**RE: RESPONSES TO MATTERS FROM THE NARRABRI UNDERGROUND MINE STAGE 3 EXTENSION PROJECT
VIRTUAL SITE TOUR AND BRIEFING**

Narrabri Coal Operations Pty Ltd (NCOPL) presented a virtual site tour to the Independent Planning Commission (IPC) on 2 February 2022 and attended a briefing on 4 February 2022 regarding the Narrabri Underground Mine Stage 3 Extension Project (the Project). These videoconferences provided opportunities for the IPC to ask questions regarding the existing/approved Narrabri Mine and the Project.

WHITEHAVEN COAL
NARRABRI STAGE 3 PROJECT
Koala Landscape Distribution

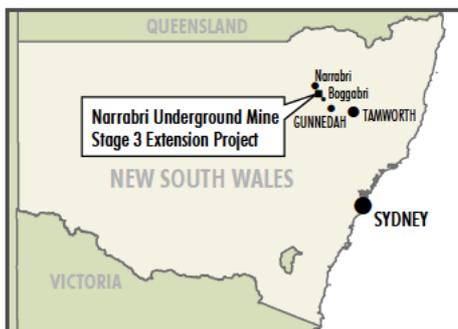
The IPC queried whether biodiversity surveys for the Koala on areas adjacent to the Project had been undertaken.

In NSW, west of the Great Dividing Range, Koalas occur in the Pilliga East State Forest and in the Gunnedah area with smaller groups elsewhere (Department of Environment and Climate Change, 2008)³. Figure 1 shows the Koala distribution map based on DPIE records. This indicates that the Koala records are generally scarce in the vicinity of the Project, and more densely recorded in various other areas.

WHITEHAVEN COAL
 NARRABRI STAGE 3 PROJECT
 Modelled Brine Re-injection Boreholes

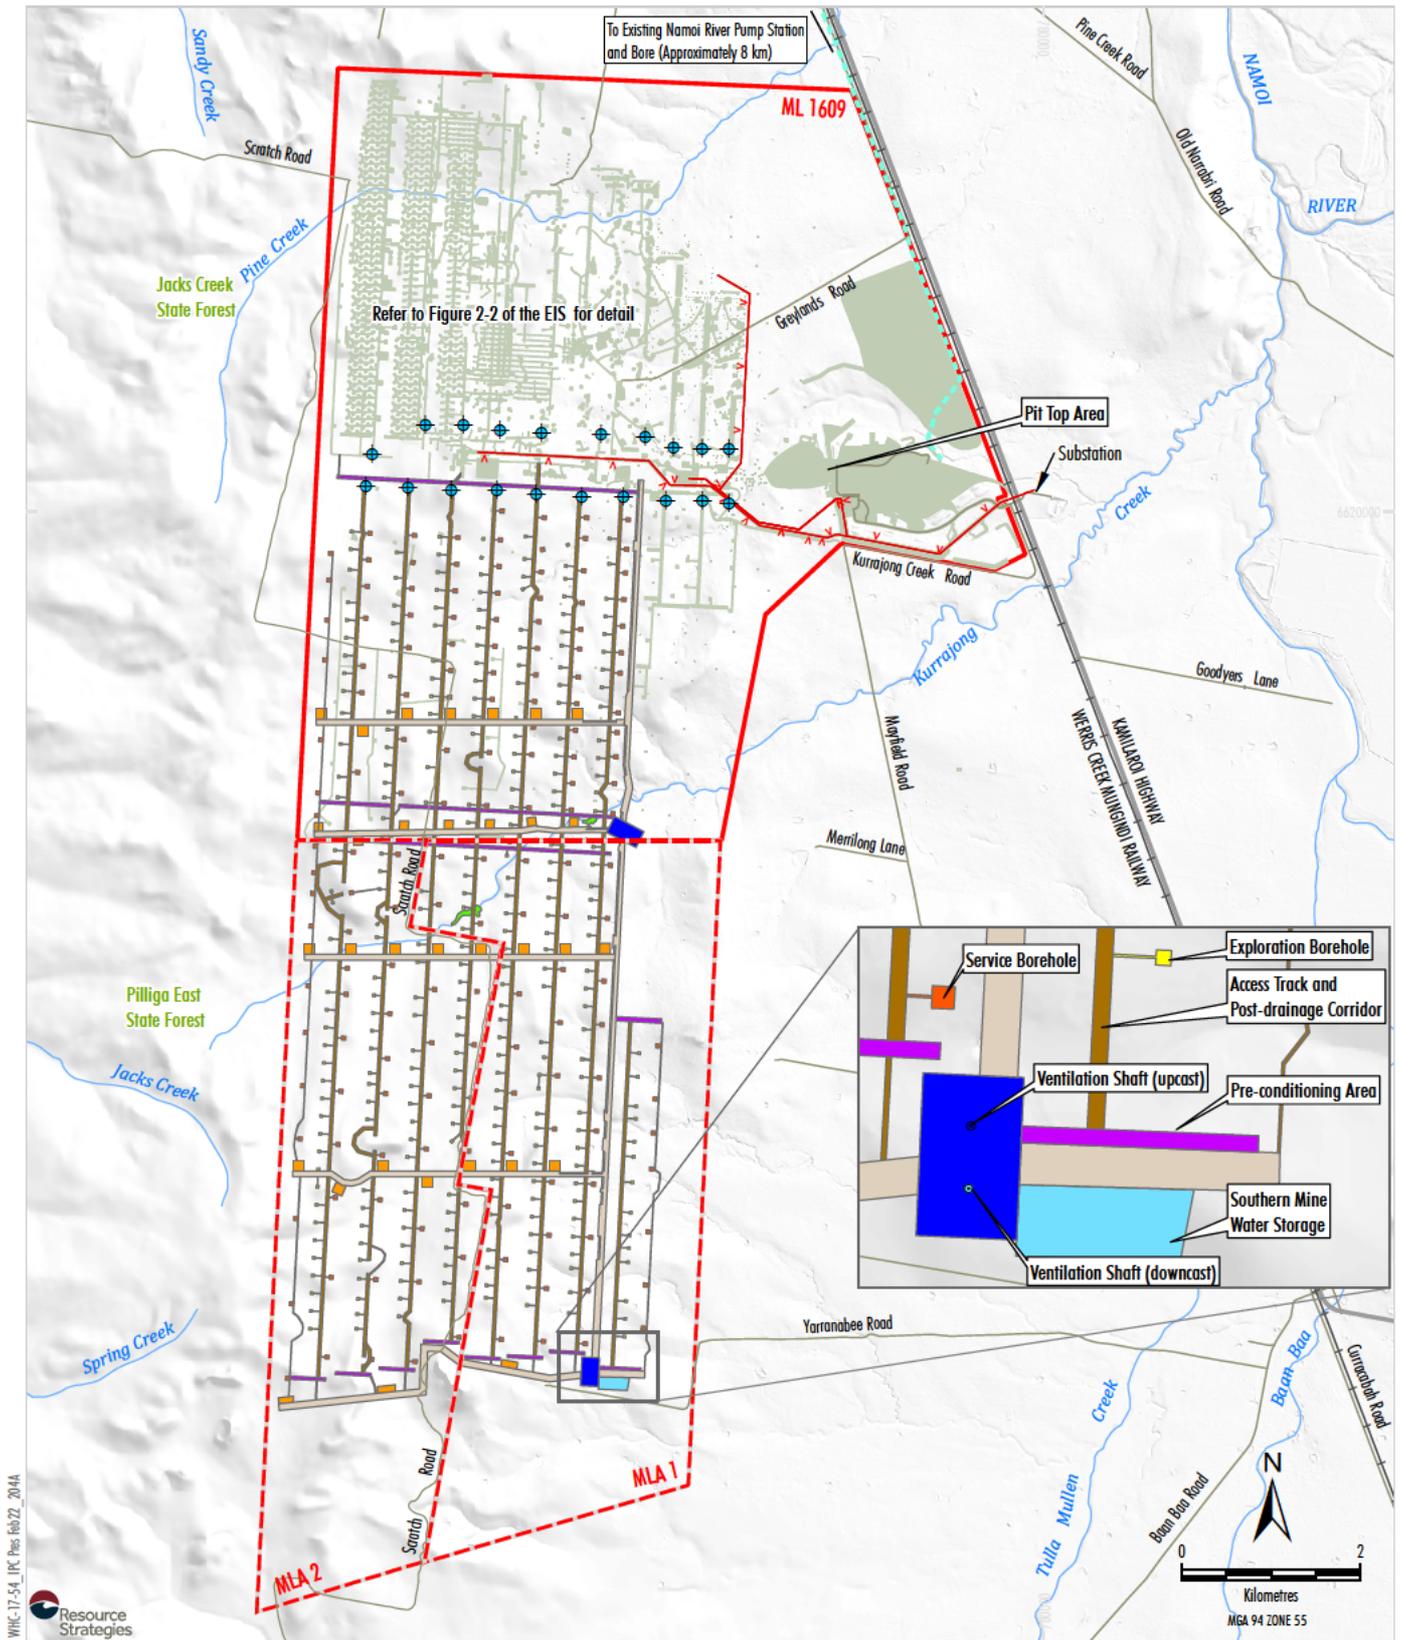
The IPC queried the extent of the goaved area that would be used for brine re-injection.

As described in the Groundwater Assessment (Australasian Groundwater and Environmental Consultants Pty Ltd [AGE], 2020)⁴, brine re-injection is likely to occur over a period of three years post-mining via a series of 20 re-injection bores targeting goaf areas towards the southern end of the 100 series and northern end of the 200 series panels. The indicative locations of the brine re-injection boreholes are shown on Figure 2. As shown on Figure 2, re-injection would be undertaken above several of the mined-out longwall panels.
